PROJECT: Summiton West V22 - Kestrel Creek Avenue (Street 1)

CITY OF LAS VEGAS		DATE:
INTER-OFFICE MEMORANDUM		December 2, 2019
TO: Land Development Services Department of Building & Safety		FROM: Albert Sung, P.E. Flood Control Project Engineer Department of Public Works
SUBJECT:	COPIES TO:	
Drainage Study for:	Atkins	
Summerlin West V22 – Kestrel Creek Avenue (Street I) (from Desert Foothills Drive to Kettle Ridge Drive <Street J>)		
Cross Streets:	Desert Foothill Drive & Kestrel Creek Ave.	Howard Hughes Company, LLC
File Number:	F:\Depot\DSMemos\DS5171C.doc	Bart Anderson, P.E., DevCo
Parcel Number:	137-14-401-006 & 137-23-101-002	
Zoning Action:	N/A	
FEMA Flood Zone	YES	NO X
Proposed Storm Drain	YES X	NO

Kestrel Creek Avenue (Street I): Desert Foothills
Drive to Kettle Ridge Drive (Street J)
Technical Drainage Study

Supplement #1 to Addendum #1

STORM DRAIN LATERAL PROFILE

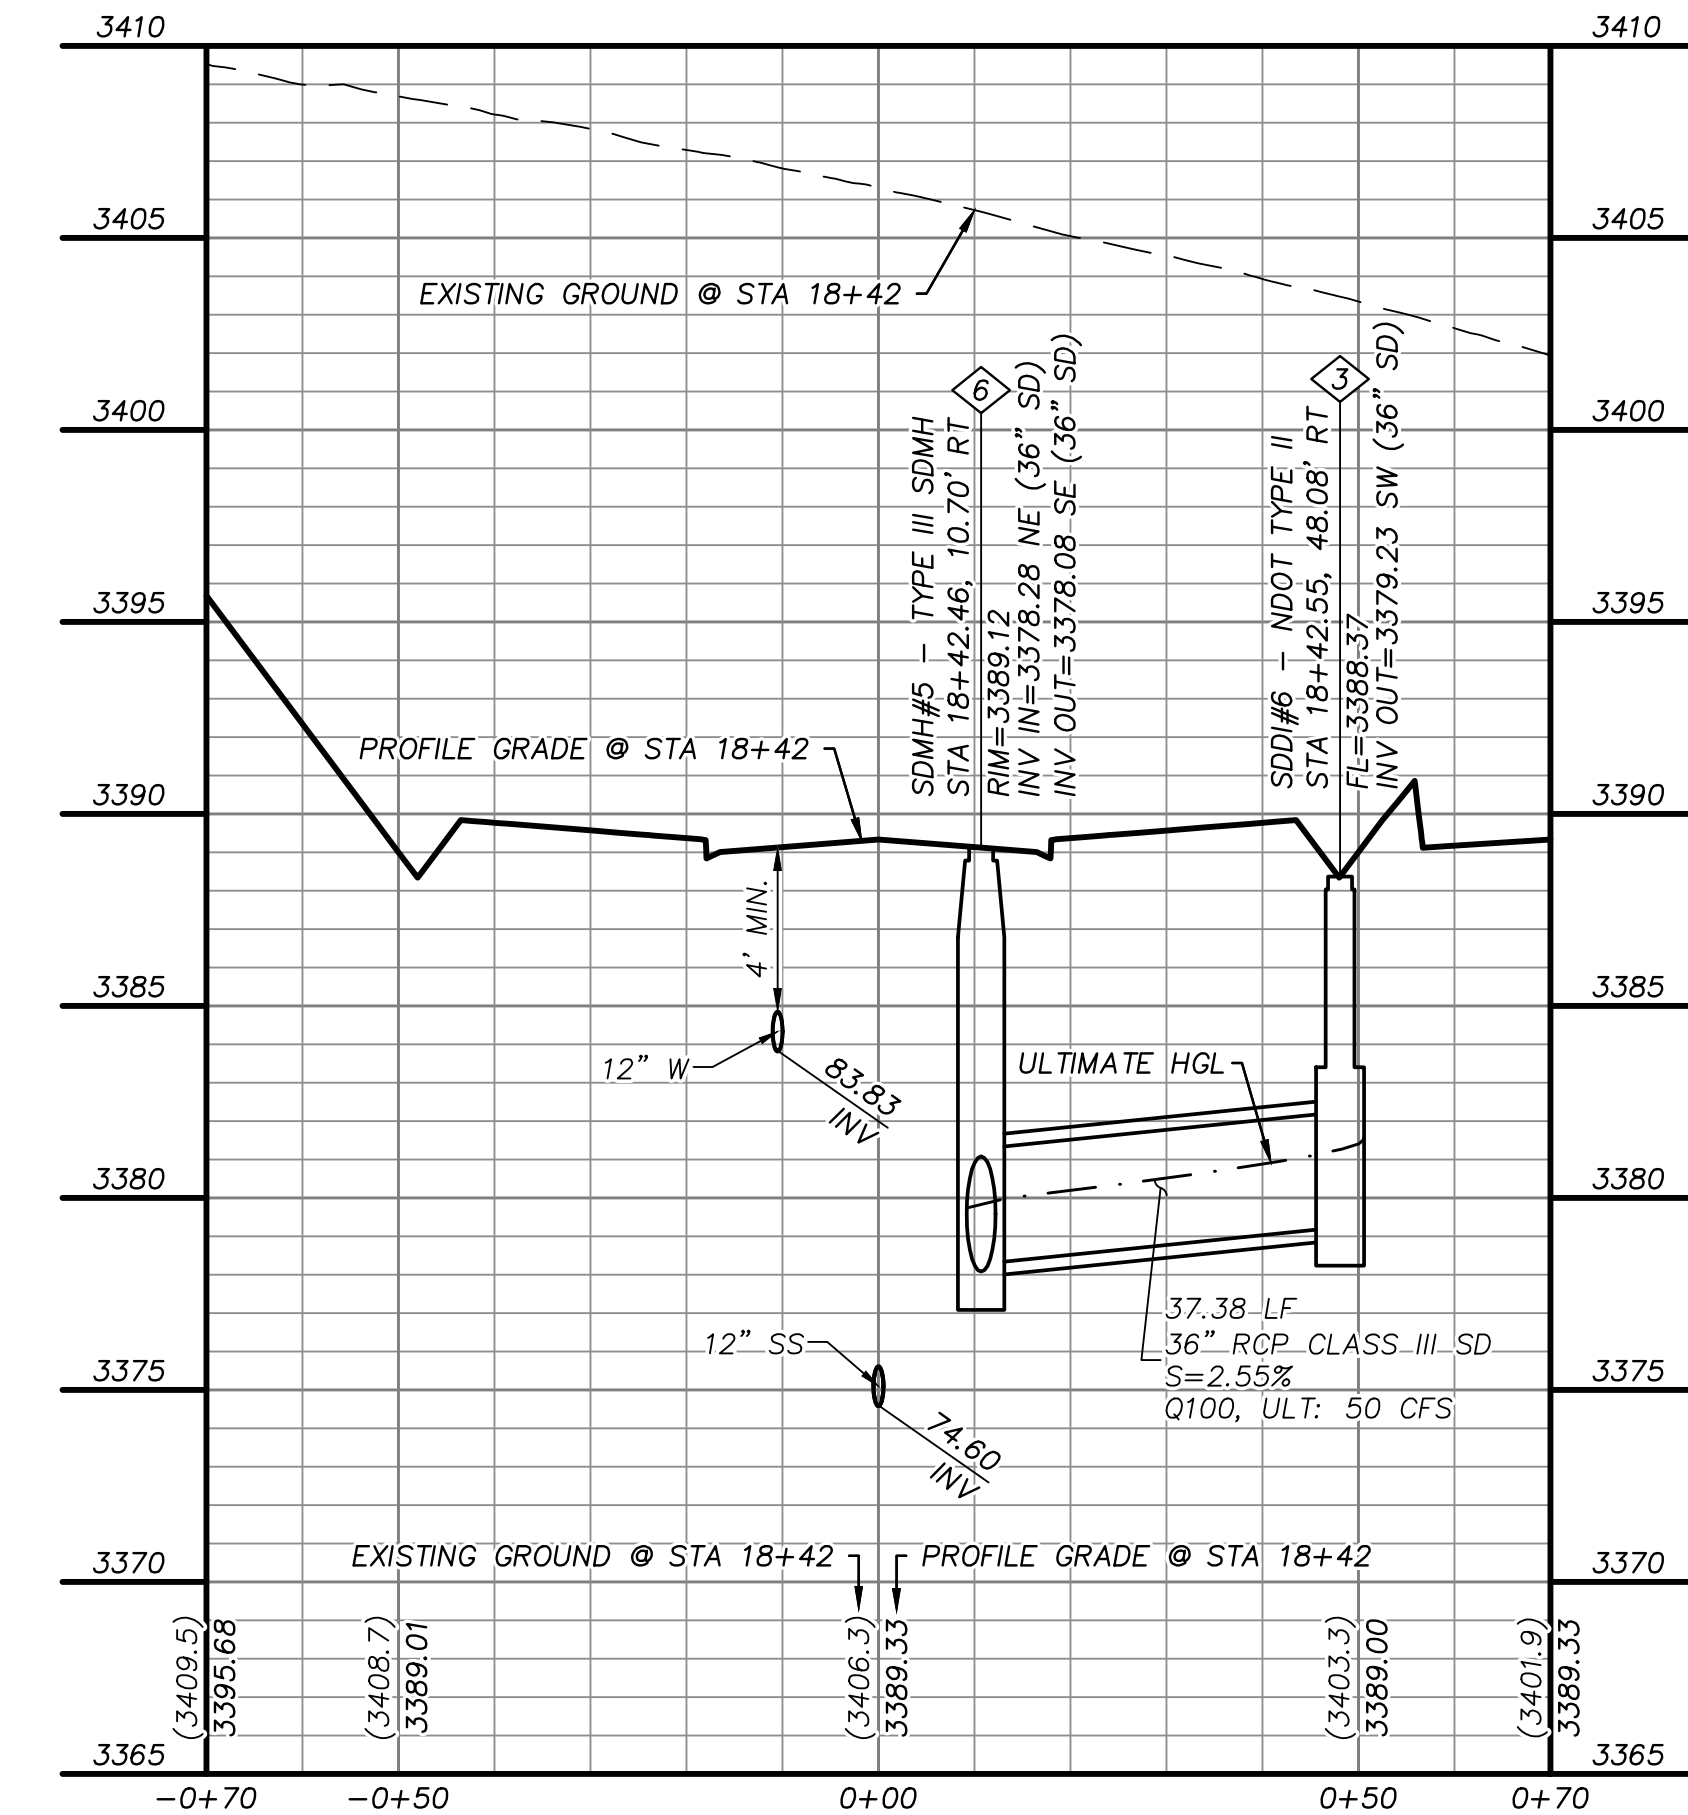
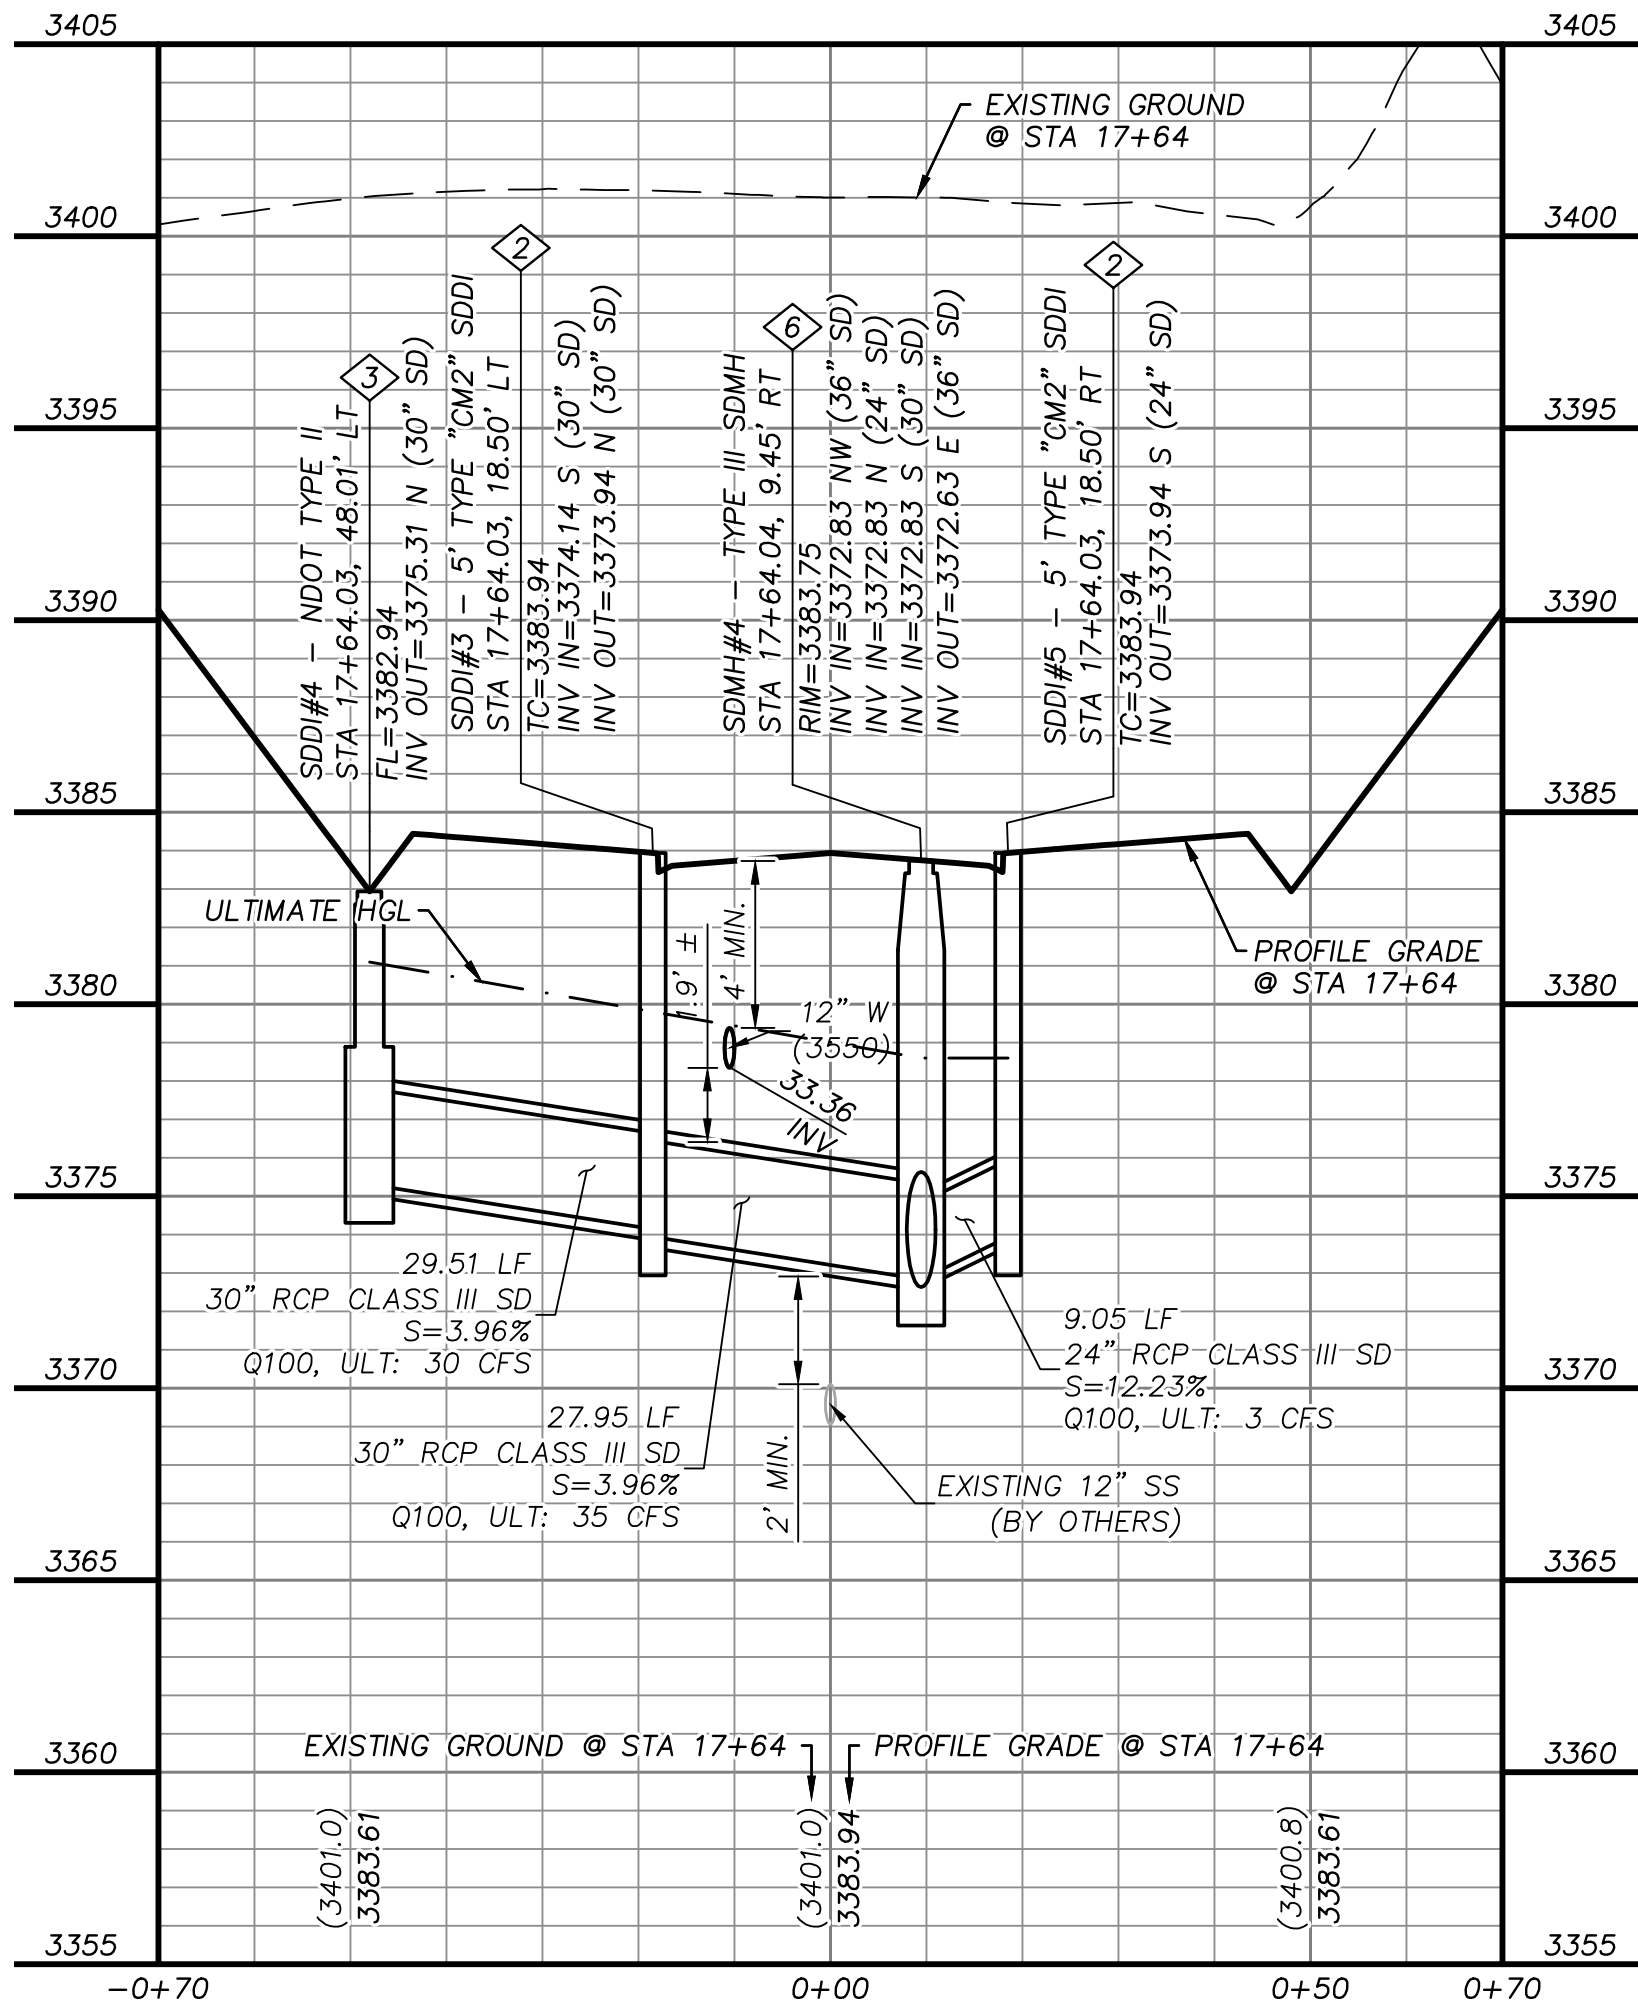
On Sheet 21/31, since you did not label the depth of the inlets clearly, I went on visually measuring the depths from the profile and found that the inlets are more than 10' deep from the flow line to the bottom. So label the depth of each inlet clearly and revise the profile to visually convincing.

The response that all drop inlets had been modified to less than 10' in depth was found not true. Per Sheet 21/31 (Storm Drain Lateral Profiles), proposed drop inlets SDDI #1, SDDI #2, and SDDI #4 are schematically shown to be deeper than 10'. This must be resolved prior to the final approval of the study.

Comment response: The drop inlets proposed by this report have been modified and are all under 10' deep from flow line to invert out per CCAUSD Dwg. No. 412.1.
